### **DESIGN/PROCESS CHANGE NOTIFICATION**

Description of Change (From) : Non potting type, copper exposed hole.

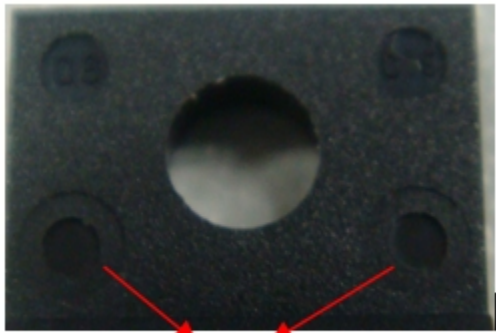
Description of Change (To) : Retract molding, EMC filled hole.

hole filled

1. Molding process standardization
2. Productivity improvement
